ITEM-5	POST EXHIBITION PLANNING PROPOSAL - 488 OLD NORTHERN ROAD, DURAL (1/2016/PLP)
THEME:	Balanced Urban Growth.
OUTCOME:	7 Responsible planning facilitates a desirable living environment and meets growth targets.
STRATEGY:	7.2 Manage new and existing development with a robust framework of policies, plans and processes that is in accordance with community needs and expectations.
MEETING DATE:	8 AUGUST 2017 COUNCIL MEETING
GROUP:	STRATEGIC PLANNING
AUTHOR:	ACTING PRINCIPAL COORDINATOR - FORWARD PLANNING BRENT WOODHAMS
RESPONSIBLE OFFICER:	ACTING MANAGER FORWARD PLANNING JANELLE ATKINS

This report recommends that the planning proposal, seeking the following amendments to LEP 2012 for land 488-494 Old Northern Road, Dural, proceed to finalisation:

The purpose of this report is to consider the outcomes of the public exhibition of the planning proposal, DCP amendments for land at 488-494 Old Northern Road, Dural (Lot 2 DP839151).

**Figure 5**

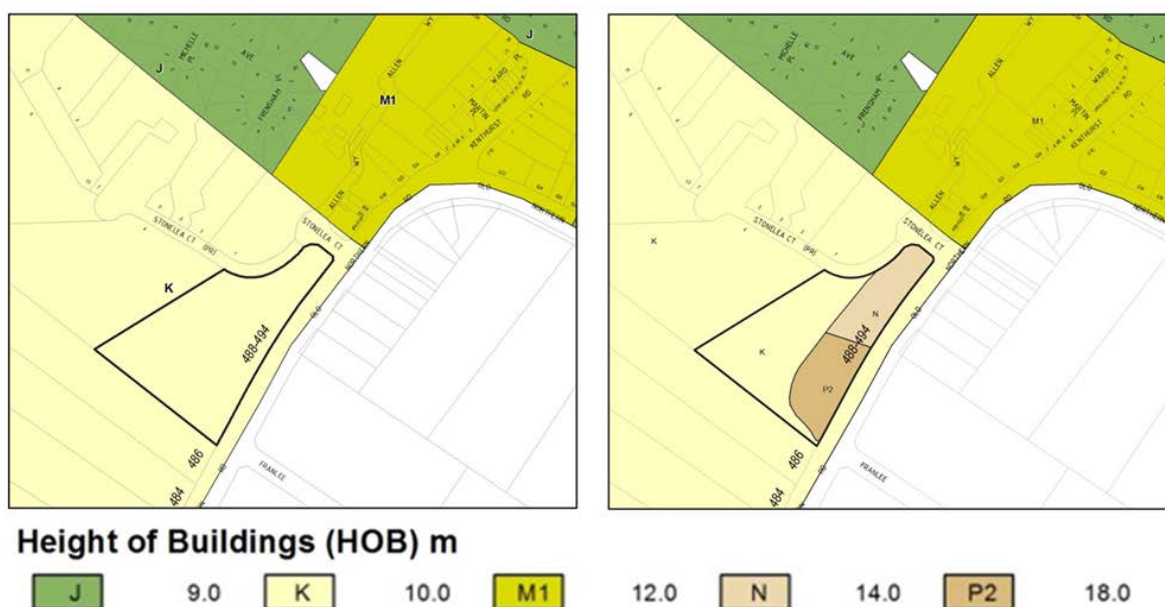
Concern is raised with respect to the proposed height and density of the proposed development. Submissions comment that the 18 metre height limit is excessive given the context of Round Corner and the transition from the commercial area to the adjoining RU6 Rural Transition Zone. Further comments identify that there is an insufficient buffer between the rural land and the 18 metre height limit area.

The proposed residential flat building on the southern end of the site will provide the opportunity for a unique gateway marker for the entrance to the town centre and deliver increased housing diversity and choice for the locality. The increased residential population will have positive benefits in supporting and activating the town centre, particularly out of normal business hours. Whilst the development will reach five (5) storeys which is taller than the permitted height which currently applies to the remainder of the Village, it is justified in this instance as it will provide a clear entry point to the Village. It is recognised that the proposed building will adjoin land zoned RU6 Transition with a height restriction of 10 metres (generally would allow 3 storeys). However the future development on the site will be seen in the context of the broader Round Corner Village rather than the surrounding rural landscape. Whilst it is generally preferred that height and density transition downward toward more sensitive interfaces, this can be taken into account as part of future master planning for the Round Corner Village which will define the edge of the Village.

Figure 8
Shadow Diagrams – 9am, 12pm and 3pm on 22 June

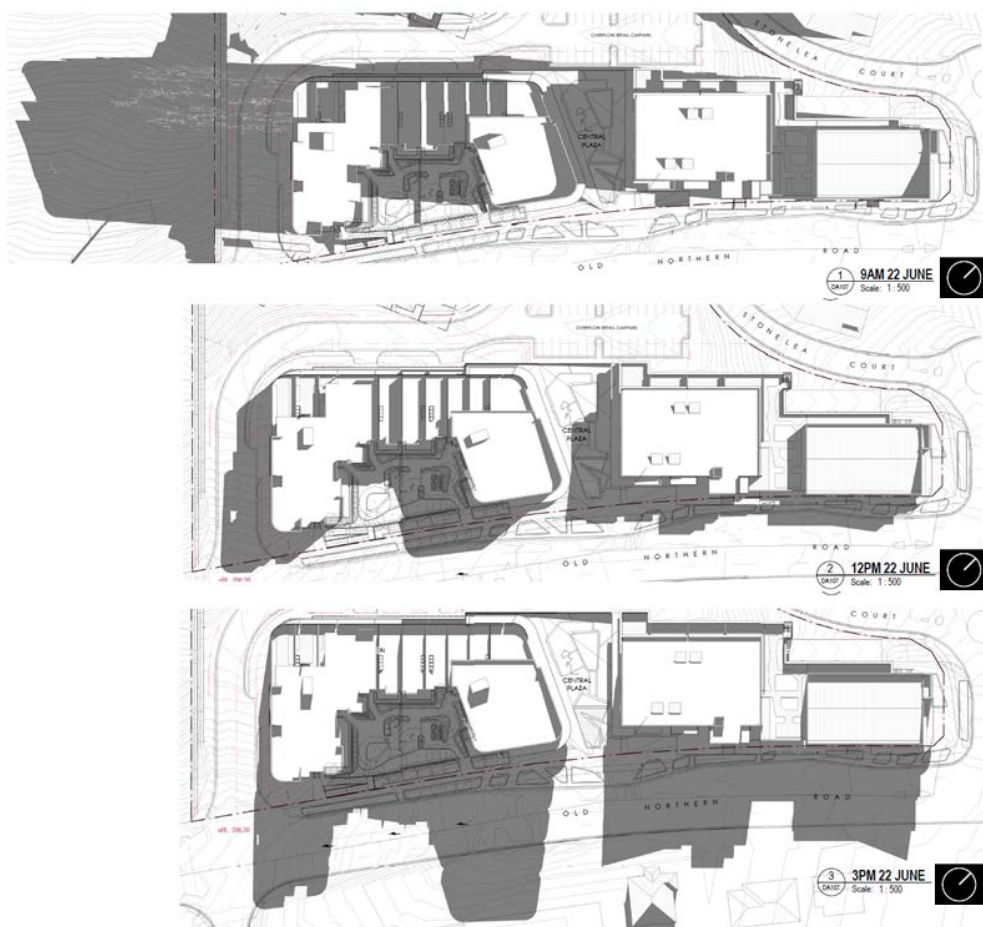
Comment:

Shadow diagrams have been prepared in support of the development application for stage 2 and are included below.

DCP 2012 requires that dwellings should be sited to allow adequate provision for access of direct sunlight to private open space within the subject land and on adjacent properties. At least 50% of the required private open space within the subject property and that on adjoining properties is to receive direct sunlight for a minimum of 4 hours between 9am and 3pm on 21 June.

Figure B E – Key principles for development

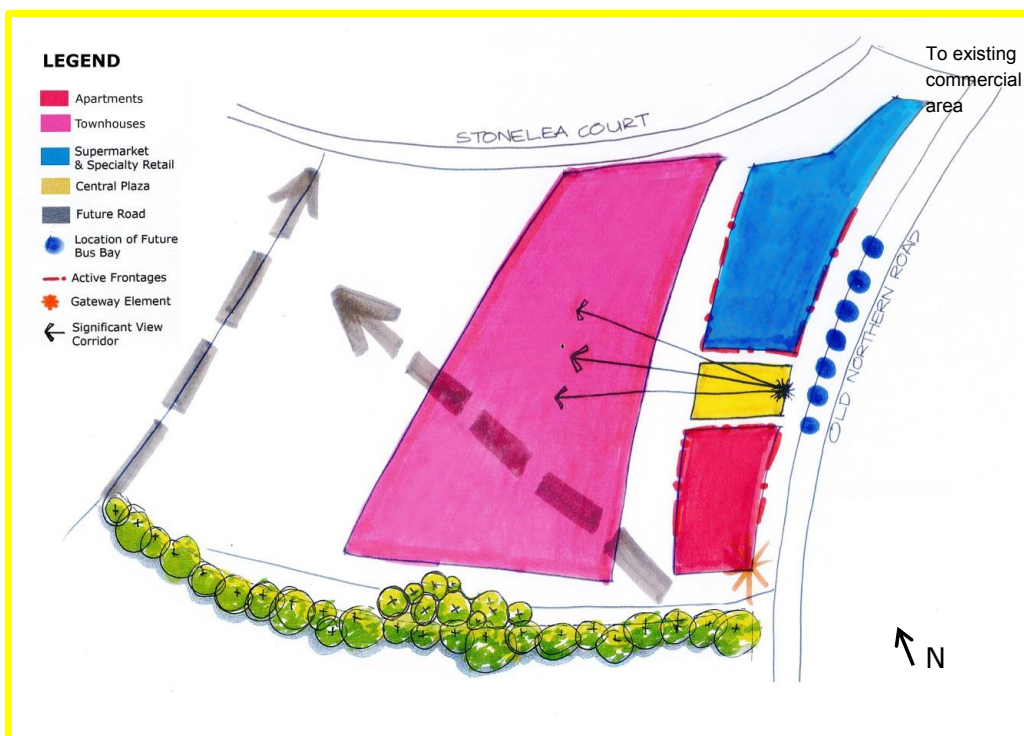
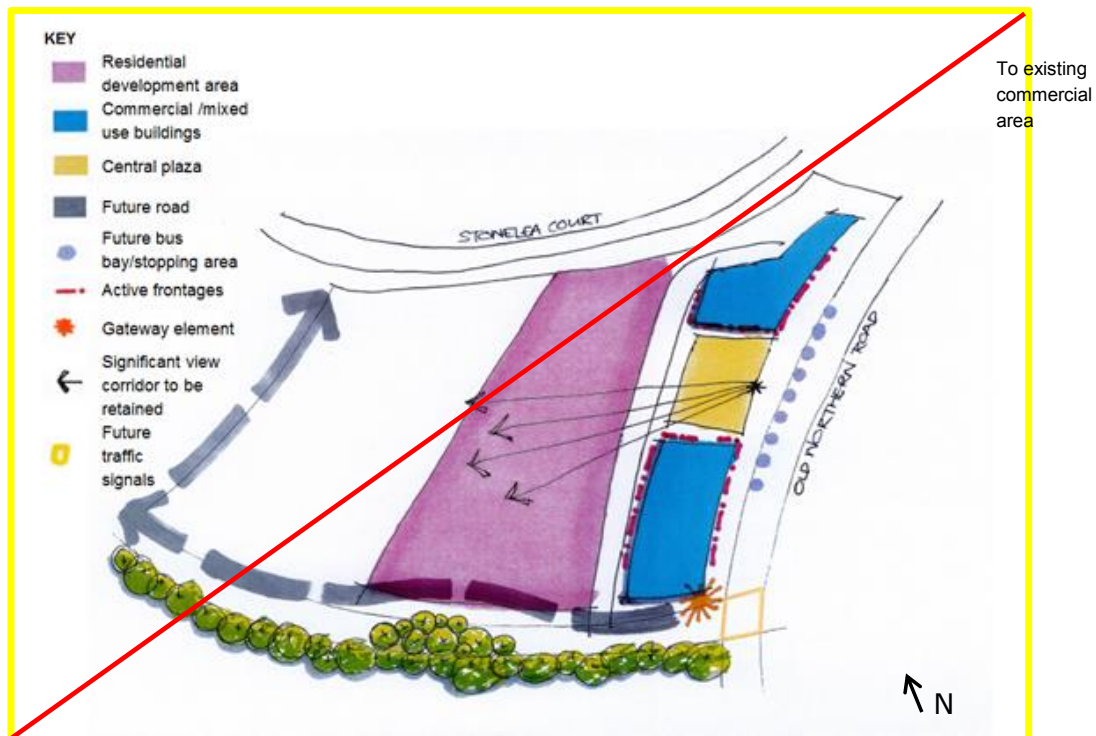
TfNSW supports the control 2.31.6 Public Transport within the DCP which requires the provision of a public bus stop and bus bay in conjunction with the development. However they request that an administrative update be made to control to ensure that it refers to Figure B rather than Figure E.

It is agreed that the draft control 2.31.6 Public Transport should be updated to refer to the correct figure. This is an administrative update that would be required, post exhibition. With respect to the design of the new bus facility, the development control plan requires the applicant to prepare and submit detailed plans with any development application for the site to the satisfaction of Transport for NSW, RMS, Council and the relevant bus operators.

It is recommended that the planning proposal proceed to finalisation as exhibited. It is further recommended Draft DCP 2012 (Part B Section 6 – Business) be adopted, with a minor amendment to control 2.31.6 Public Transport to refer to the correct figure. The control should read as follows:

- Bus facilities including a public bus stop and bus bay are to be provided in conjunction with the development of the site, along the Old Northern Road frontage of the site. An indicative location for the bus facilities is shown in Figure B. Detailed plans to the satisfaction of Transport for NSW, RMS, Council and the relevant bus operators shall be submitted with any development application for the site.
